**ORDINANCE NO. 594**

**AN ORDINANCE AMENDING THE WILSONVILLE COMPREHENSIVE PLAN BY ADOPTING THE AMENDED VILLEBOIS VILLAGE MASTER PLAN AS AN ANCILLARY DOCUMENT**

LP2005-02-00006

Figure 6A

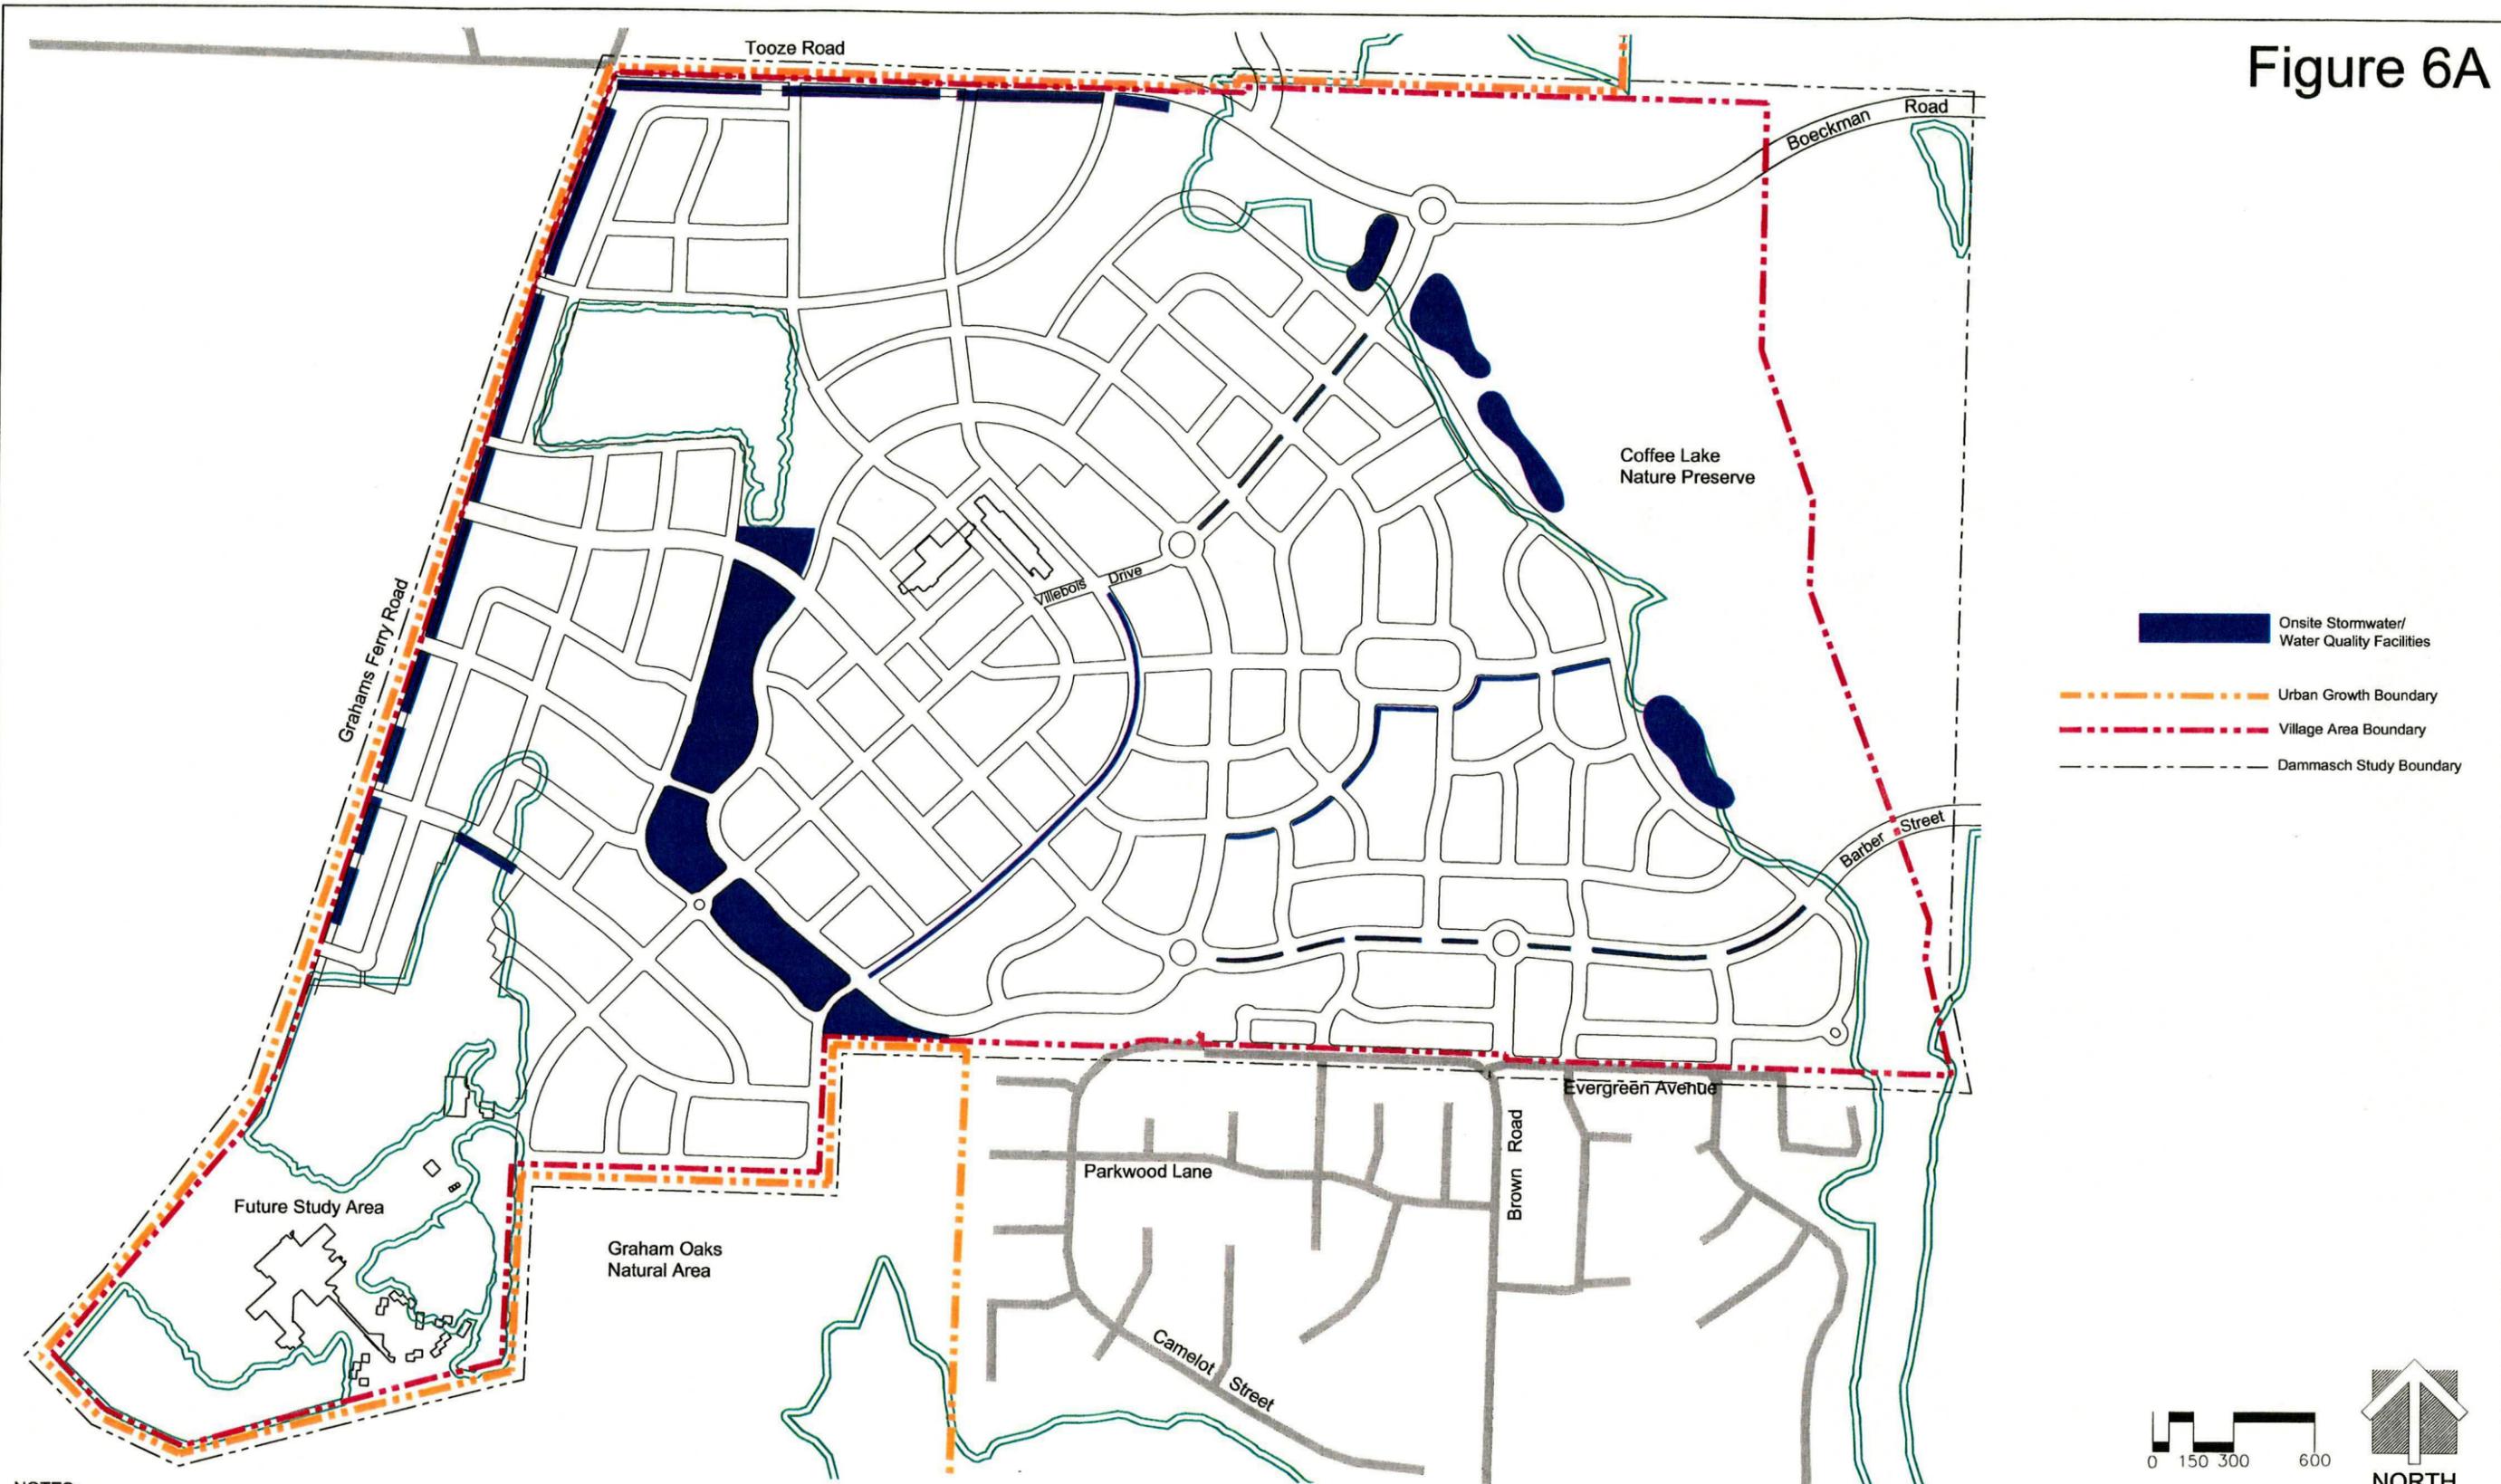
Figure 6A has been modified to show updated stormwater facilities in SAP East adjacent to Coffee Lake Creek and in SAP North. The revised Figure 6A includes the addition of stormwater facilities along Tooze Road that according to the applicant's narrative have always been a part of the plan, but were left off of all prior submittals.

Figure 7

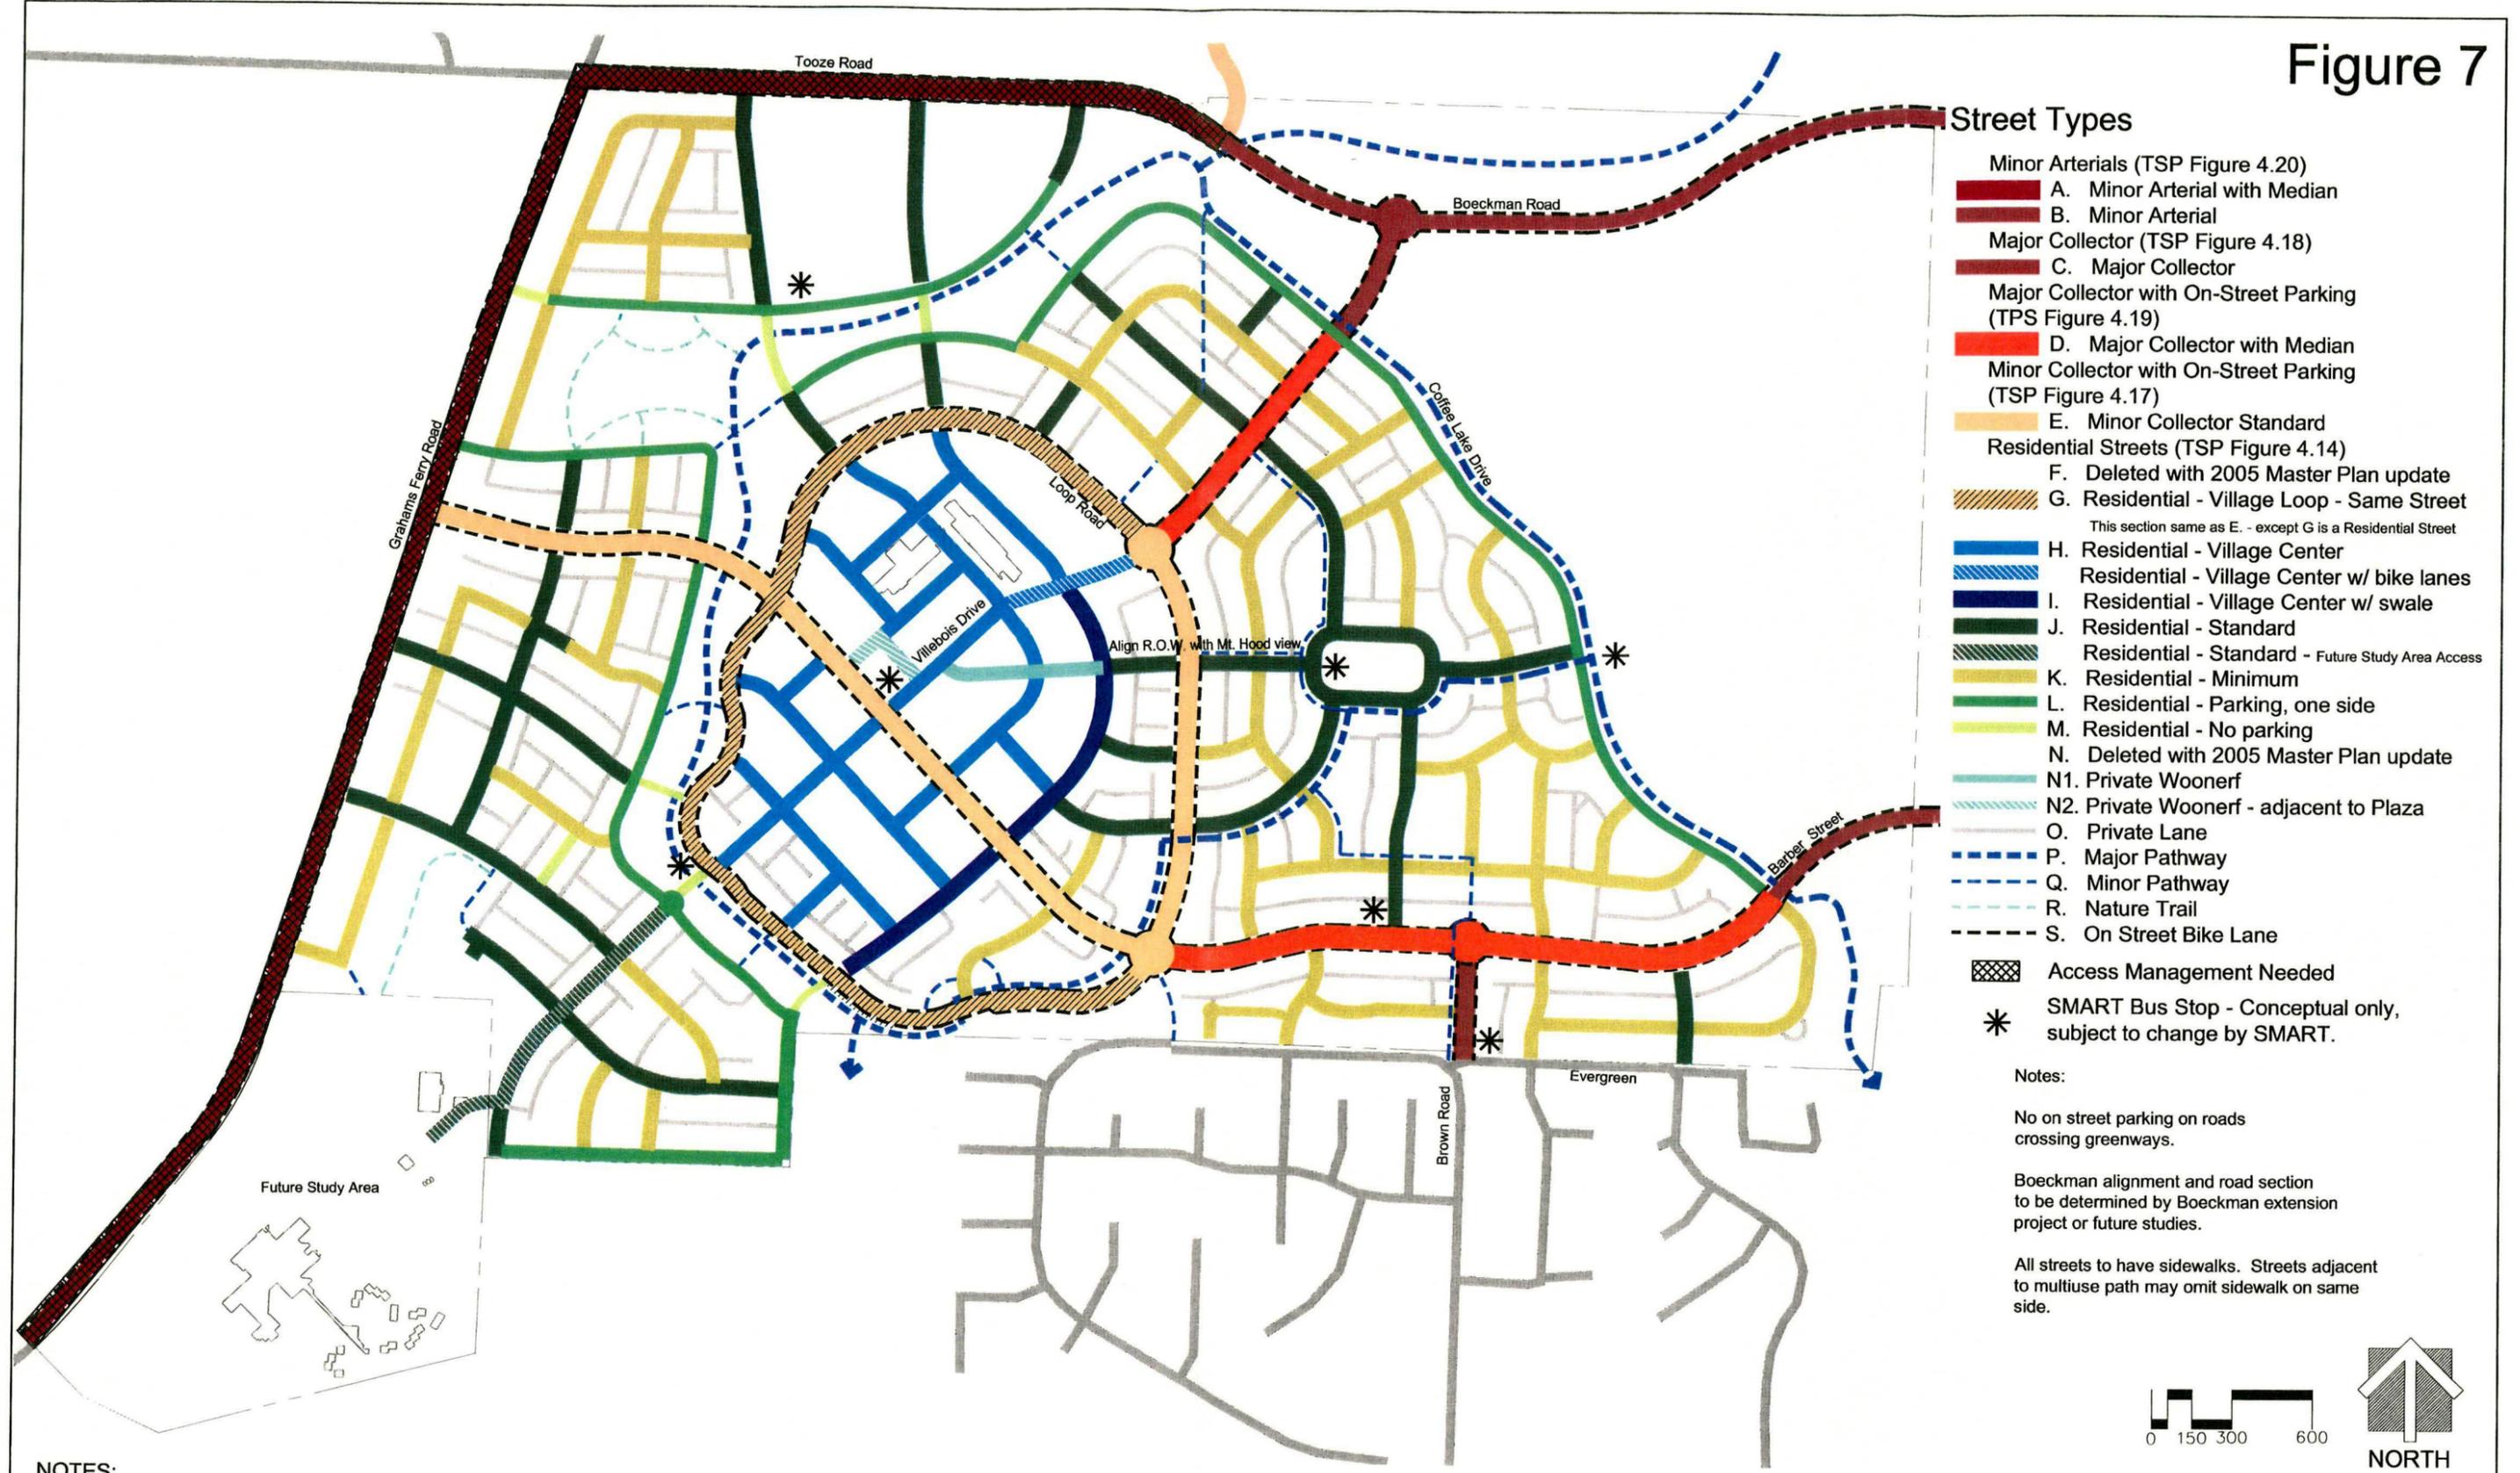
- The Access Management hatching on the legend of Figure 7 should be extended along Tooze Road in addition to Grahams Ferry Road (Please see PF 11).
- Figure 9A contains note #14 that states "*Sidewalk becomes 13.5', planting strip is removed and right of way becomes 61' when adjacent to commercial*". Staff points out that there will still need to be street trees in grates along the sidewalk for the street section H, Residential-Village Center adjacent to commercial.
